Subject: Submittal of Additional Information Concerning Remediation Activities at the
Westinghouse, Waltz Mill Site, Madison, Pennsylvania
License No., SNM-770, Docket No. 07000698

**Response to NRC Letter Dated August 10, 2001
Request for Additional Information
Concerning Remediation Activities**

**Waltz Mill Site
Madison, Pennsylvania**

**Response to NRC Letter Dated August 10, 2001
Westinghouse Electric Company, LLC
Request for Additional Information
Concerning Remediation Activities at the
Westinghouse Waltz Mill Site
Madison, Pennsylvania**

FIGURE E-1
CROP LINE AND MINED-OUT AREAS
OF THE UPPER FREEPORT COAL
WALTZ MILL SITE
MADISON, PENNSYLVANIA

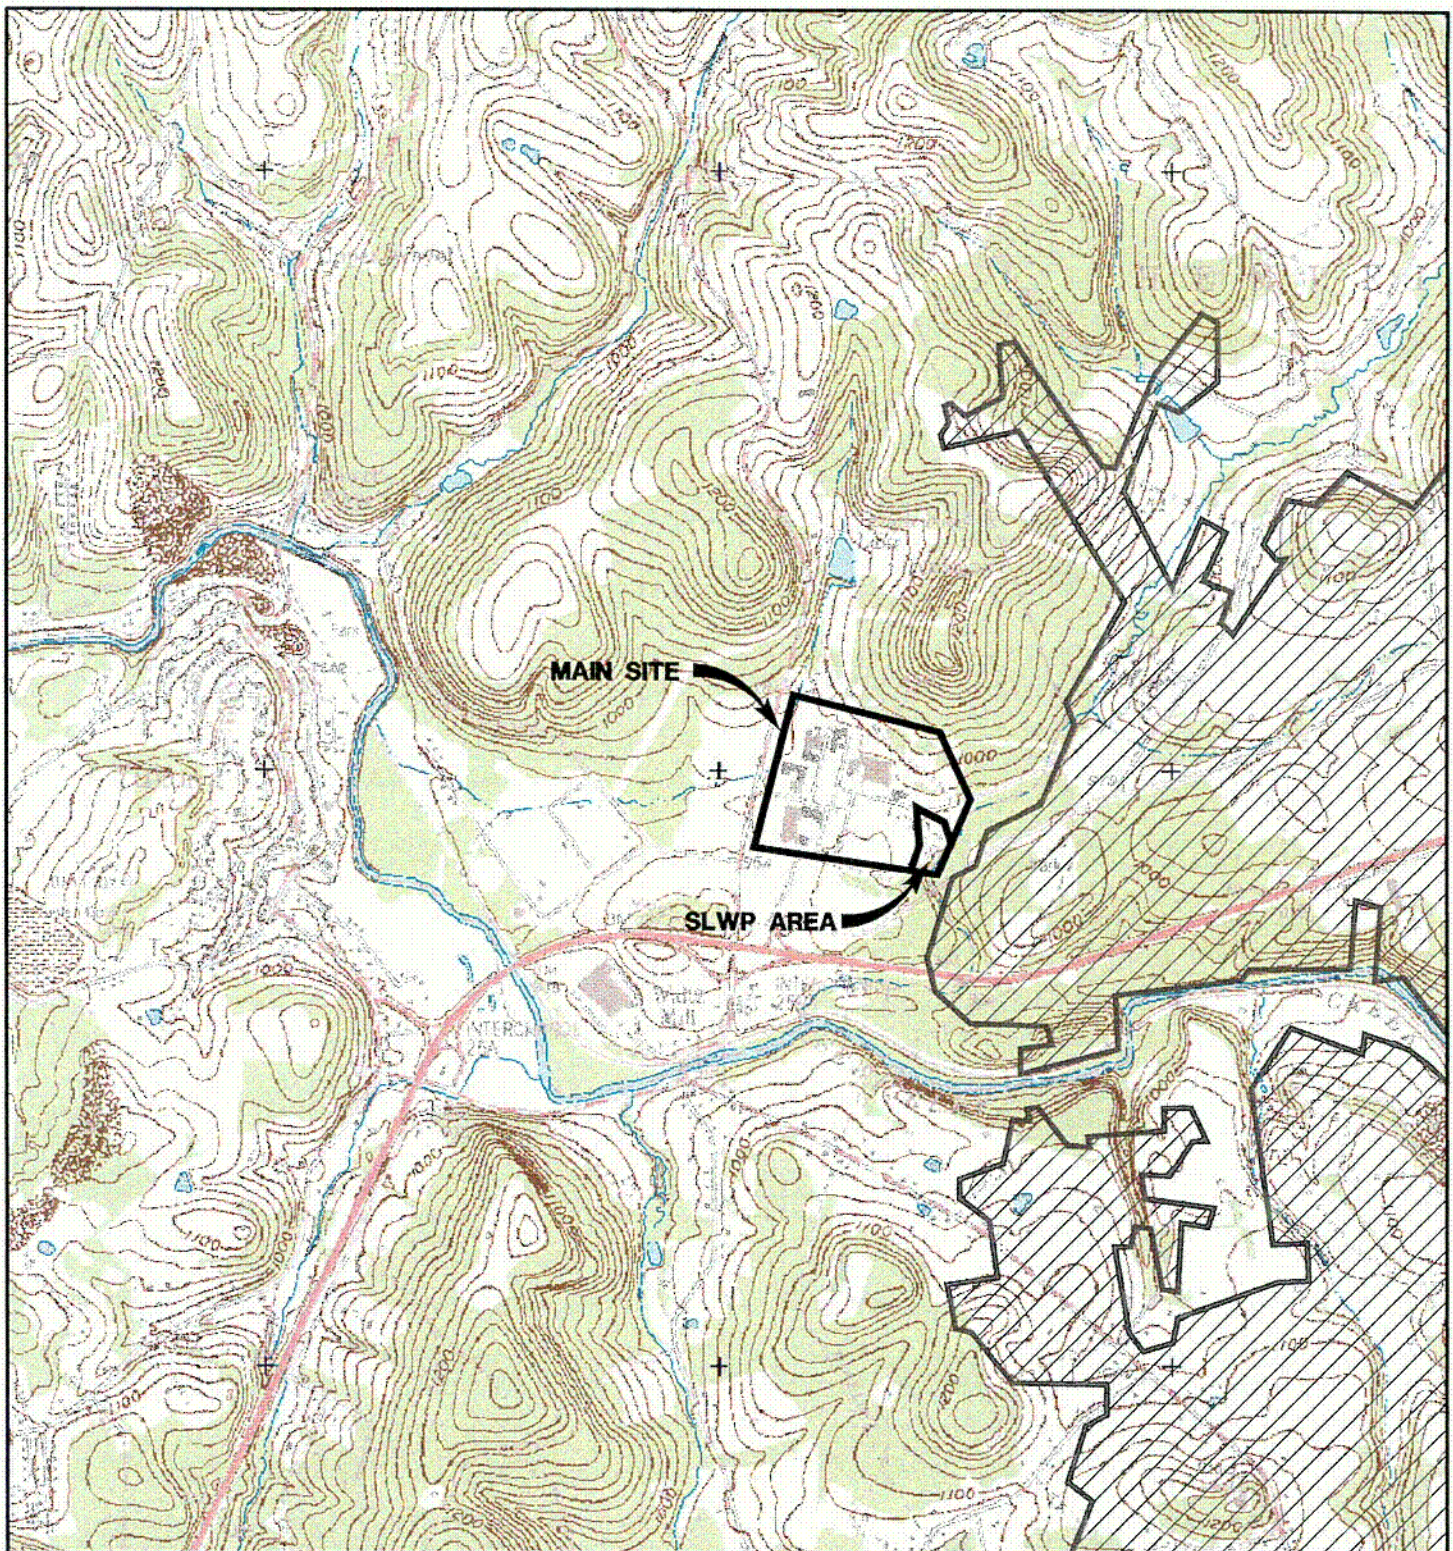
Question No. 6: Underground coal mining east of the site has the potential to cause land subsidence and groundwater redirection/diversion. Have you identified the presence of any actual mines beneath the site, and if present, what potential impact do they have on groundwater?

Response: Attachment E contains information on subsurface mining activities within the vicinity of the Waltz Mill Site. Attachment E includes a U.S. Geological Survey (USGS) quadrangle map showing the coal crop lines and structure contours of the coal seams beneath the site. A similar map illustrates mined-out areas of the Upper Freeport Coal, which is the shallowest coal seam present beneath the study area. These maps indicate that the Upper Freeport Coal is approximately 115 feet (Calley's Run area) to 150 feet (former LWRB area) below ground surface. The structural dip of the coal seam is to the west at about 185 feet per mile or 2 degrees. Because of the changes in topography over the site and the dip of the coal, the Upper Freeport Coal is approximately 200 feet below ground surface within the former test reactor area.

Mined-out areas of the Upper Freeport Coal are not located directly beneath the SLWP area. As illustrated in the attached USGS map, deep mining of the Upper Freeport Coal has occurred east of this area and just east of Calley's Run. There is no field indication of subsidence nor is it expected to any great degree in the SLWP area, based on the relative depth and distance of the mined-out areas from the SLWP area. Deep-mining operations can result in increased fracturing of overlying bedrock units resulting in a dewatering of the overlying water-bearing zones. The presence of a continuous water-bearing zone beneath the SLWP area indicates that dewatering of this monitored zone is not occurring, which again is expected based on the depth and distance of the mined-out areas. In conclusion, deep mining has not occurred beneath the SLWP area and the data do not indicate that adjacent mining activities have had an effect on groundwater flow directions.
